Item Name: Dual High Back Seat Installation

DART SERVICE INSTRUCTION

TO AMEND INSTALLATION INSTRUCTIONS IIN-D350-689 REV. B
AND INSTRUCTIONS FOR CONTINUED AIRWORTHINESS ICA-D350-689 REV. 1
REF. TCCA STC: SH02-33
REF. FAA STC: SR01620NY
REF. EASA STC: EASA.IM.R.S.01453
REF. TCA STC: 2005S03-09

FIGURE 1: UPDATES TO CROSS SECTIONS F-F AND M-M
 With reference to Figures 5 and 7 of IIN-D350-689
 (Figures 25-5 and 25-7 of ICA-D350-689)

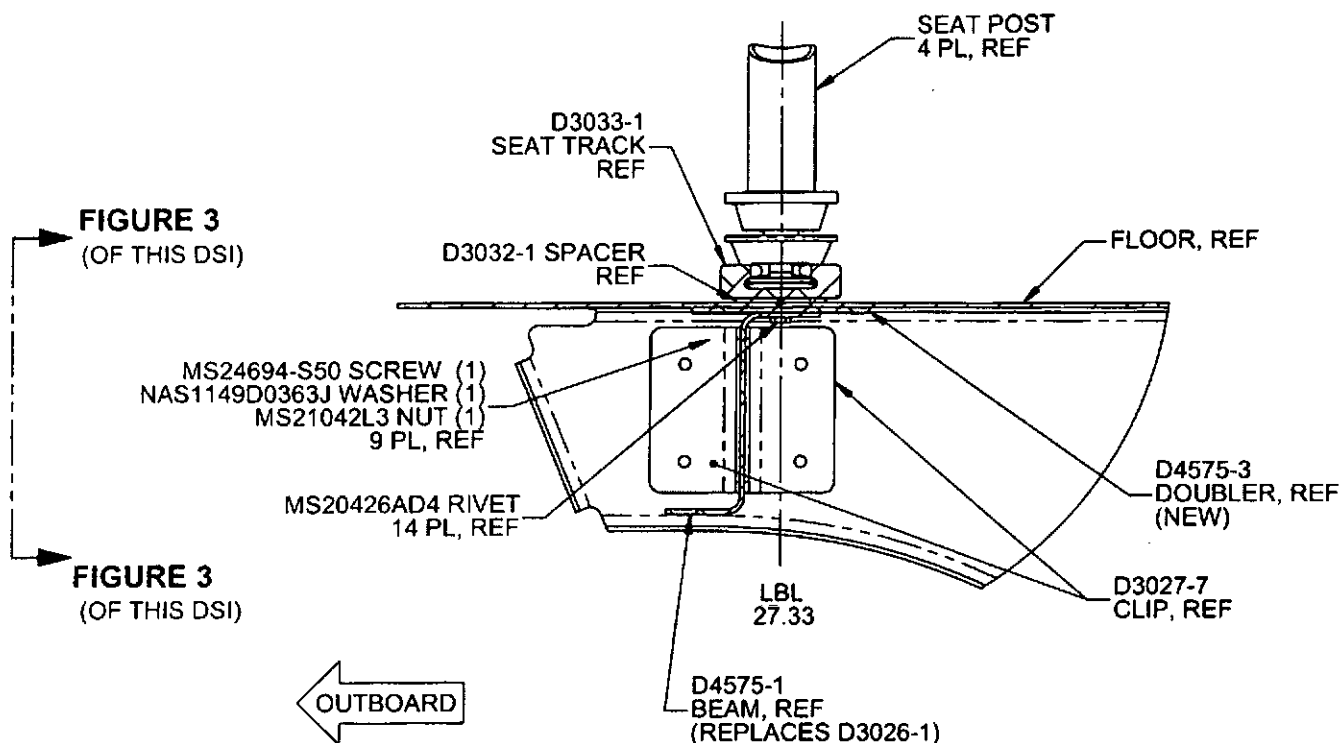
If there is an existing stringer at LBL 27.33, it will need to be removed from that location. Locate D4575-1 Beam, D4575-3 Doubler, and D3032-1 Spacer as shown in Figure 1 of this Service Instruction. Transfer drill existing holes from the aircraft floor to the D4575-1 Beam, D4575-3 Doubler, and D3032-1 Spacer. Ensure 1.0" to 1.5" rivet pitch and add additional holes if required. If there is no existing stringer, locate D4575-1 Beam, D4575-3 Doubler, and D3032-1 Spacer as shown in Figure 1 of this Service Instruction and drill Ø0.128" holes on a 1.0" to 1.5" pitch.

If there is an existing stringer at LBL 27.33, it will need to be removed from that location. Locate D4575-1 Beam and D4575-3 Doubler as shown in Figure 2 of this Service Instruction. Transfer drill existing holes from the aircraft floor to the D4575-1 Beam and D4575-3 Doubler. Ensure 1.0" to 1.5" rivet pitch and add additional holes if required. If there is no existing stringer, locate D4575-1 Beam and D4575-3 Doubler as shown in Figure 1 of this Service Instruction and drill Ø0.128" holes on a 1.0" to 1.5" pitch.

FIGURE 3: RELIEFS ON D4575-1/-3
(ONLY D4575-1/-3 SHOWN FOR CLARITY)
VIEW LOOKING INBOARD

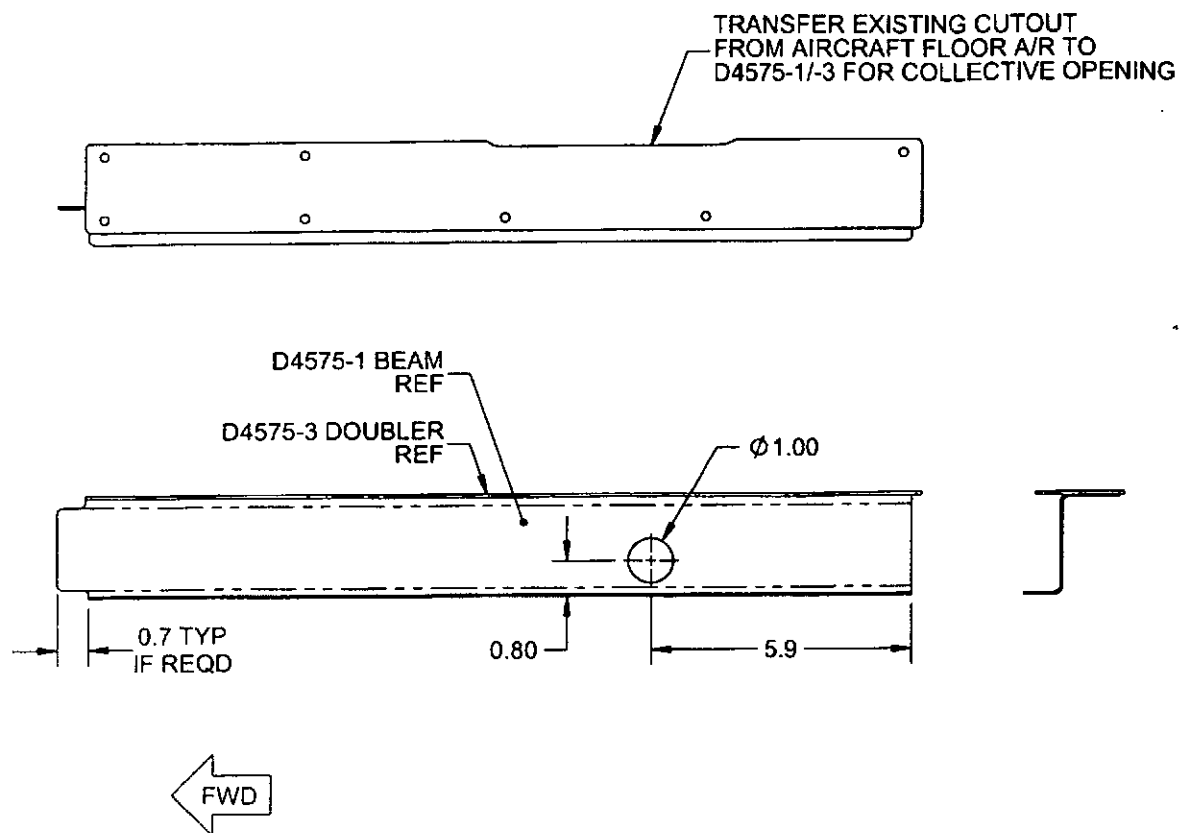
Note: Drill a Ø1.00" (Ø25.4 mm) hole in the D4575-1 Beam to clear extension tube of collective and cutout as required for clearance of collective opening and fwd bulkhead as shown in Figure 3 of this Service Instruction.

Note: Drill a Ø1.00" (Ø25.4 mm) hole in the D4575-1 Beam to clear extension tube of collective and cutout as required for clearance of collective opening and fwd bulkhead as shown in Figure 3 of this Service Instruction.
